SUBJECT: OPERATING REACTOR EVENT MEMORANDUM NO. 81- 31:
LOSS OF DIRECT CURRENT (DC) BUS AT MILLSTONE UNIT 2

LOSS OF DC BUS AT MILLSTONE 2SEQUENCE OF EVENTS

ANALYSIS AND CONCERNS

FIGURE 1 - SHEET 1 OF 2
SIMPLIFIED ELECTRICAL
SINGLE LINE DIAGRAM
MILLSTONE-2 2/81

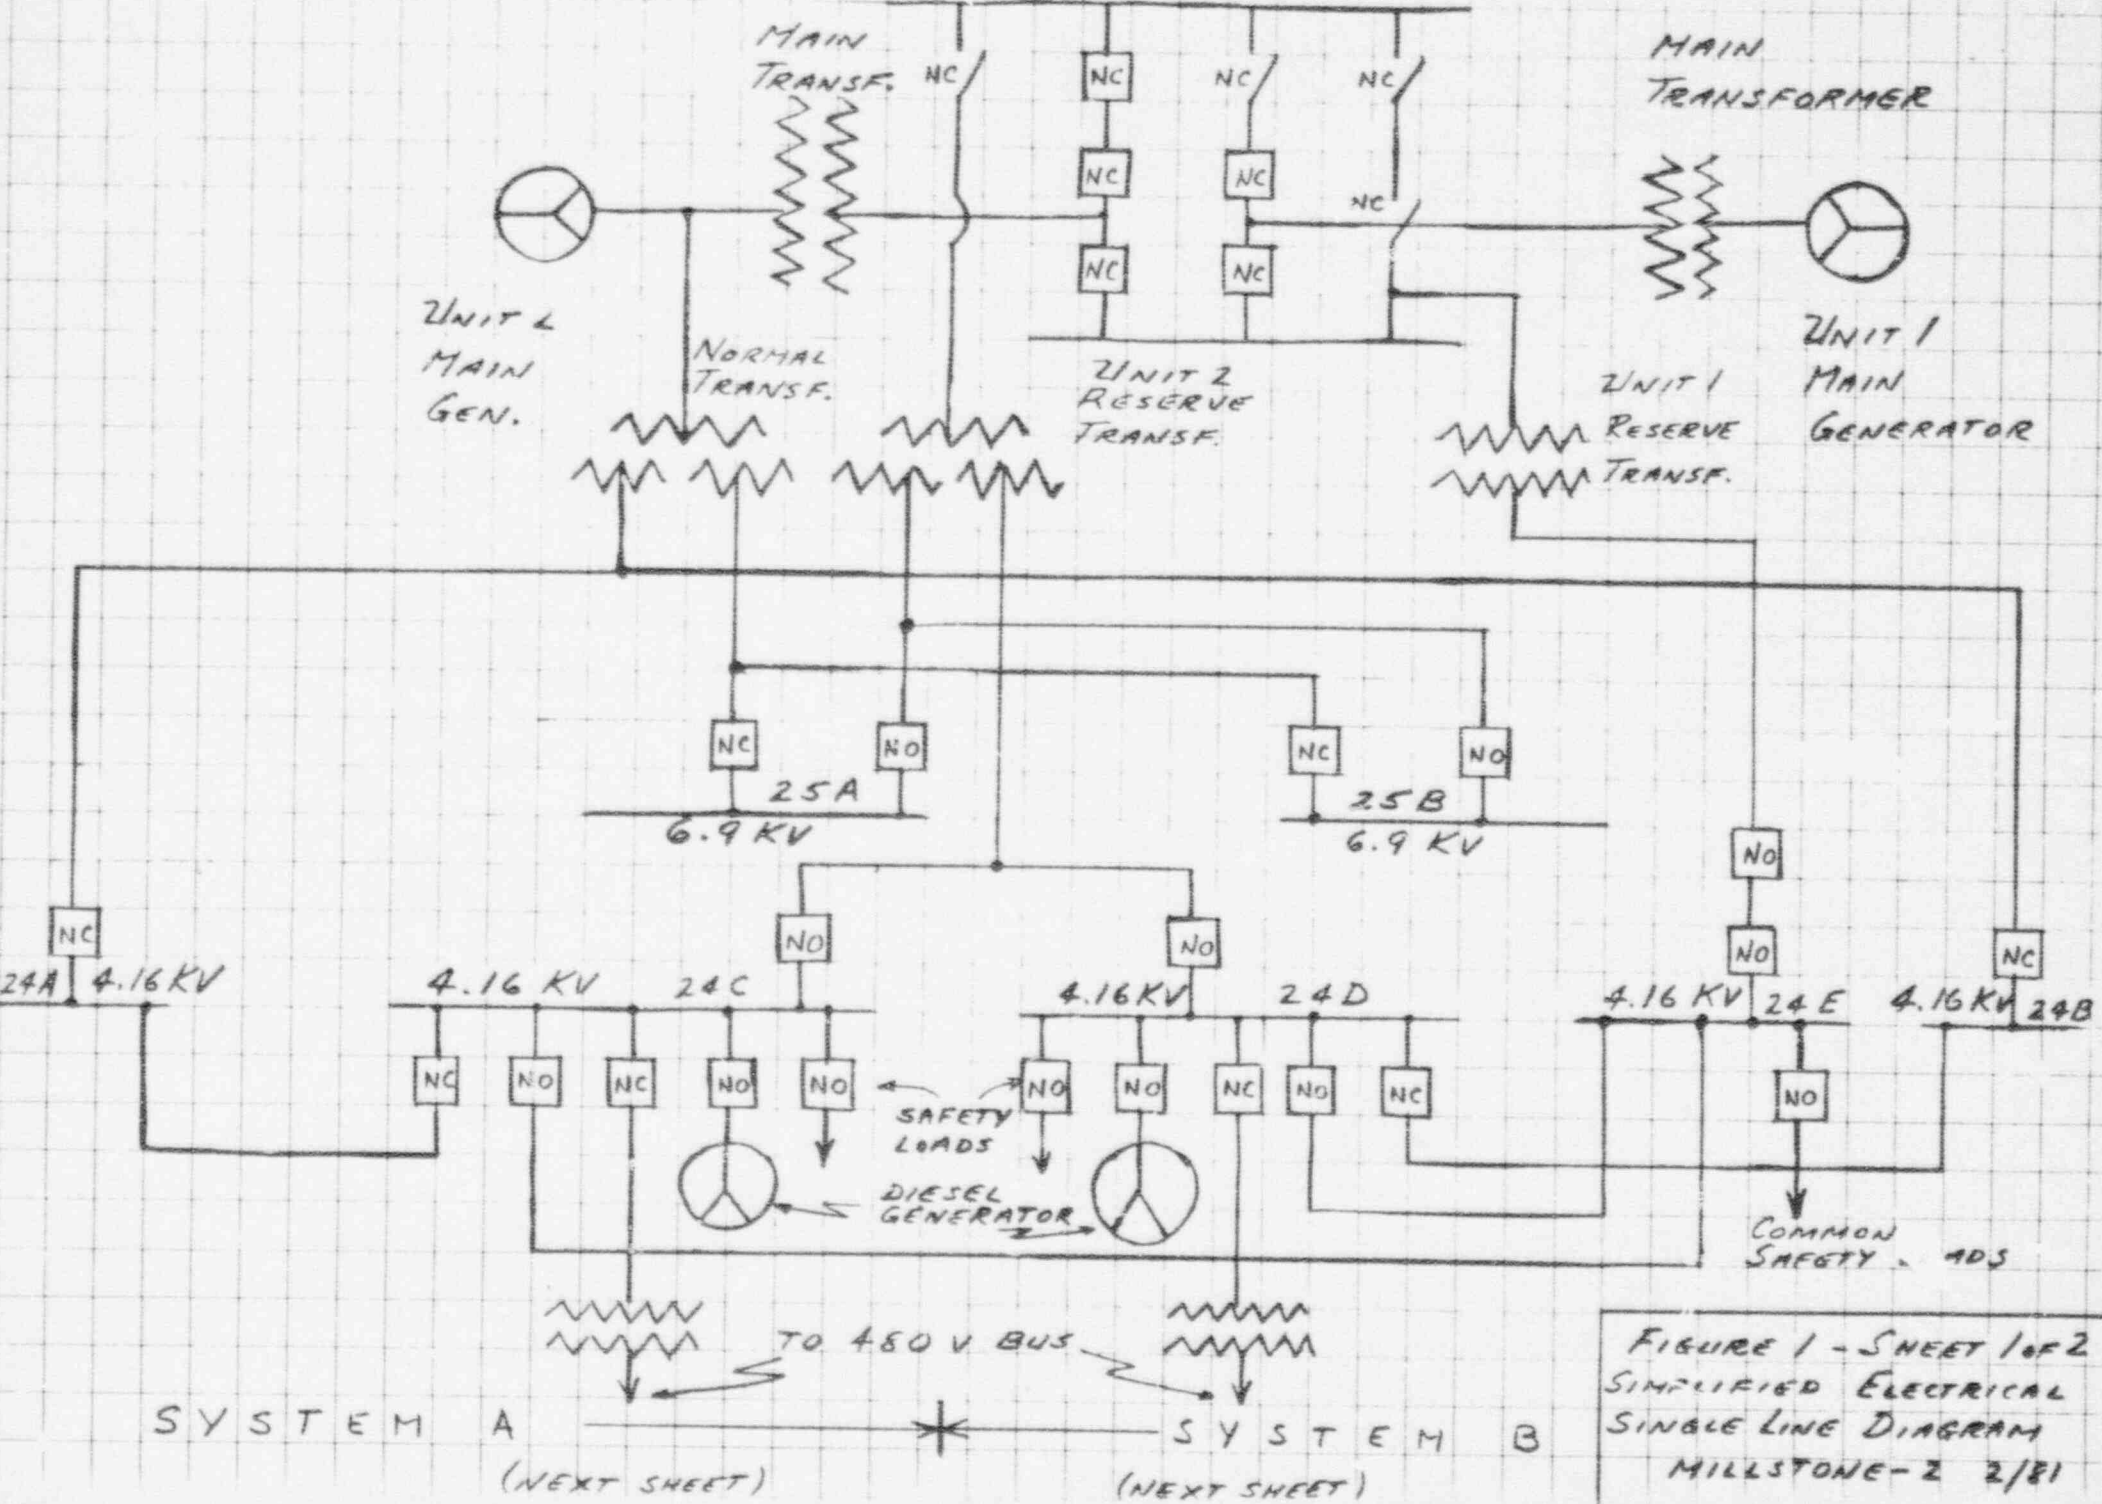
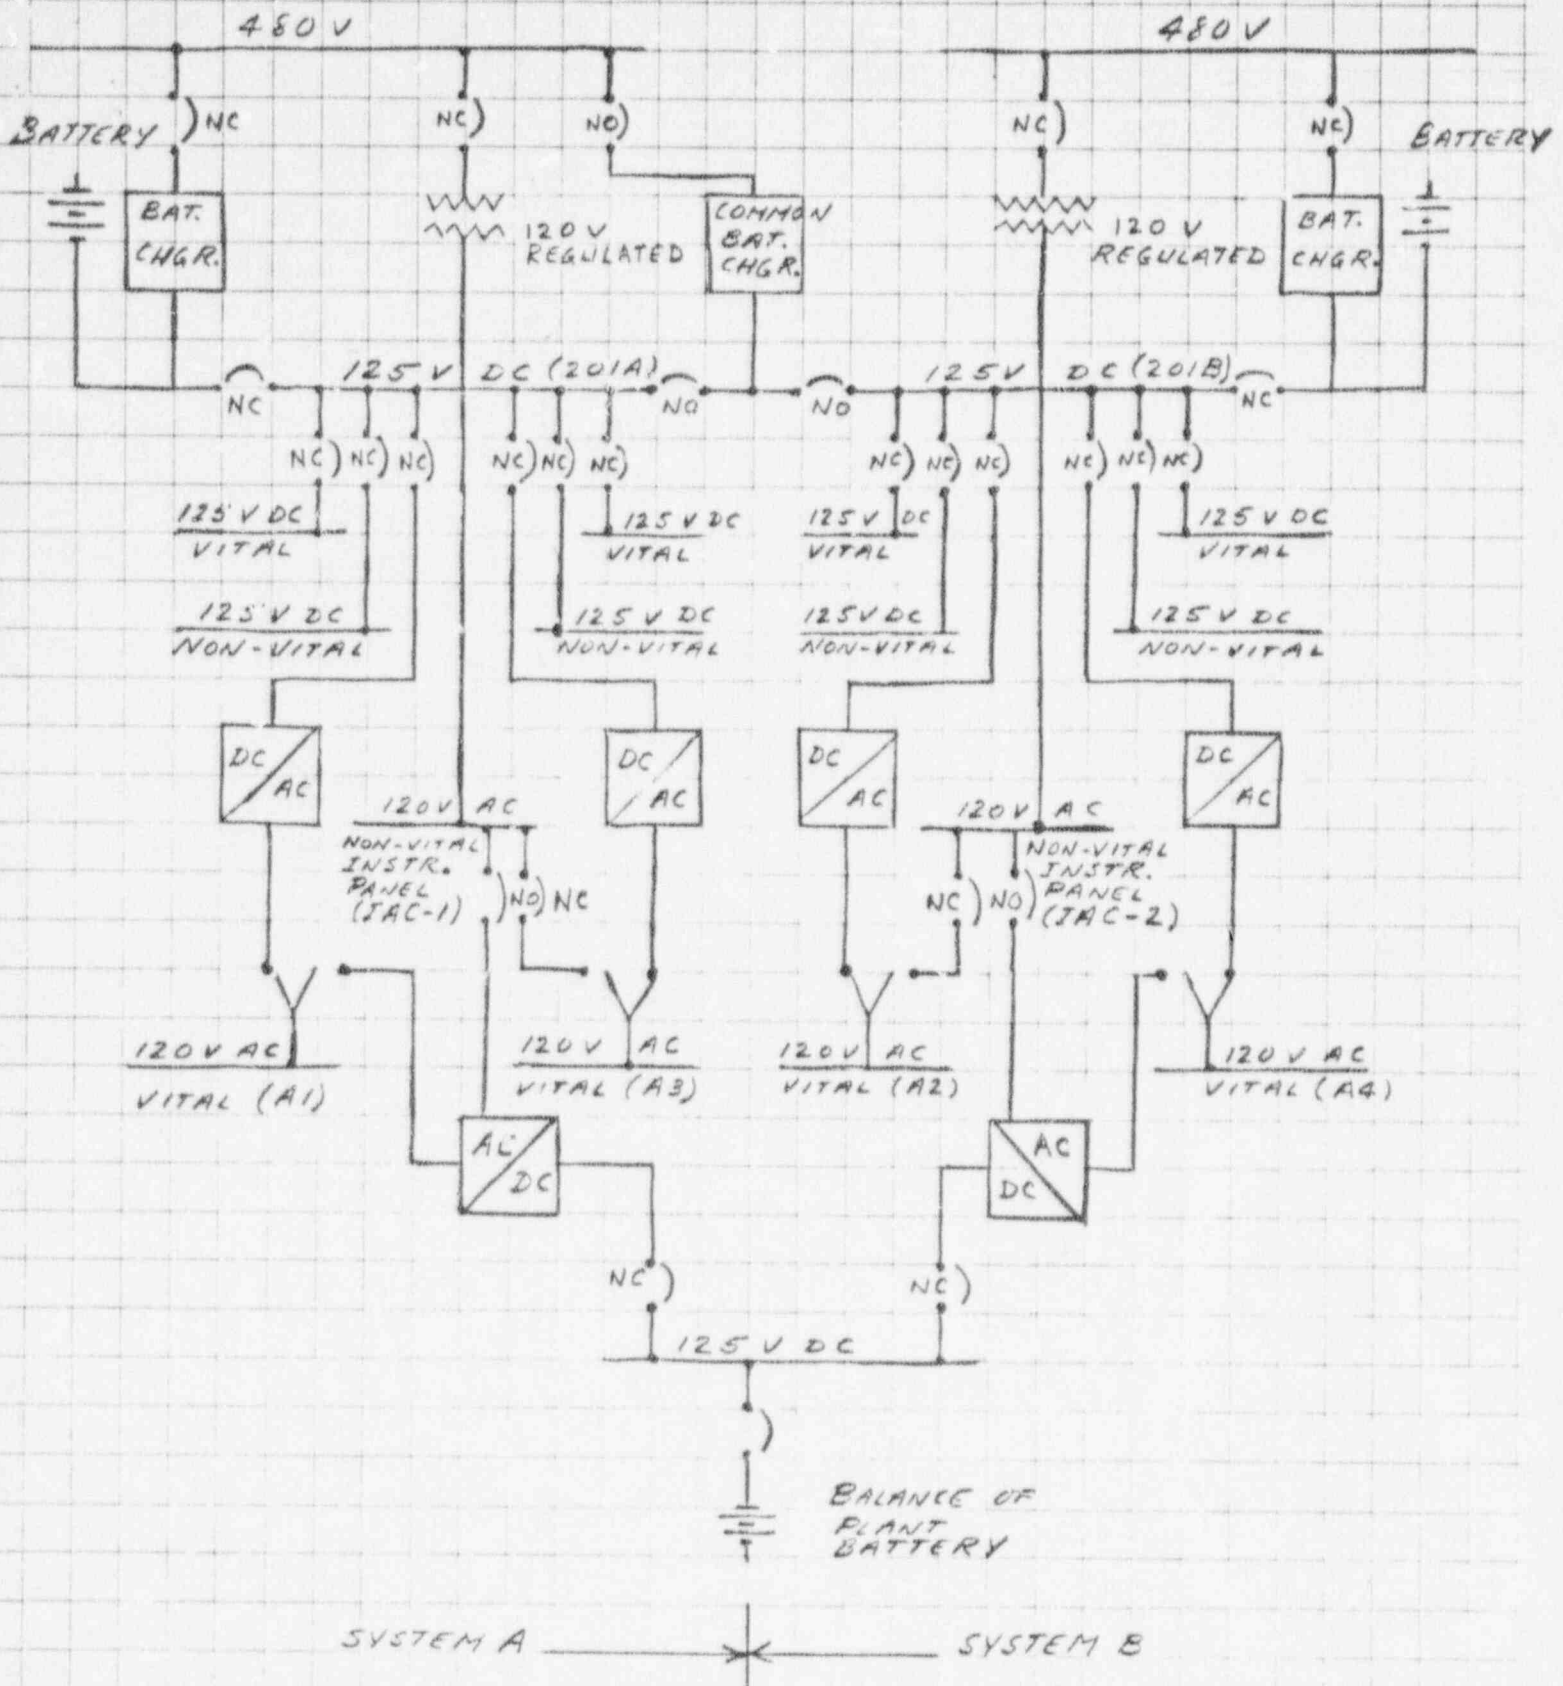
Ten minutes after the initiating event occurred, System B diesel generator experienced a malfunction caused by a water leak which sprayed the speed controller. This resulted in an underspeed condition followed by a low oil pressure trip of the diesel generator. The low oil pressure trip corresponded to a electrical frequency of approximately 45 hertz. At approximately the same time, several fuses were blown in the instrumentation loops being powered from a 120 V ac non-vital instrument panel associated with system B. This panel has been identified in the enclosed Figure 1 as IAC-2.

As a result of evaluating the effects of this event, it was noted that the independence between the two redundant electrical systems could possibly be compromised at the 120 V ac level. As shown in the enclosed Figure 1, each system has two vital 120 V ac buses and one non-vital bus. One vital bus of each system is fed automatically, upon loss of the normal source, from a dc/ac inverter for which the source of dc is the balance of the plant battery (referred as the turbine battery). The other vital bus of each system is fed automatically from the non-vital bus upon the loss of the normal supply. Each non-vital bus can also be supplied from the same dc/ac inverter connected to the balance of the plant battery and used as mentioned before as an automatic alternate source for one of the vital buses. Thus, the design provisions to assure continuity of power to the vital buses from the common balance of the plant battery could also result in the compromising of the required independence between redundant electrical systems.

It is our concern that a single event affecting the non-safety related balance of the plant battery could degrade the battery and/or its associated equipment to a point that could affect the operability of sufficient vital buses in both systems resulting in the loss of protective function when required.

- o The Operating Reactors Branch #3 should convey the following to the licensee:
 - g To examine the design and recommend modifications (including technical specification changes) that will preclude supplying either manually or automatically vital buses in supposedly independent systems from a single non-safety related bus of the plant battery at the same time. The ORAB will evaluate the licensee's recommendations in this regard.
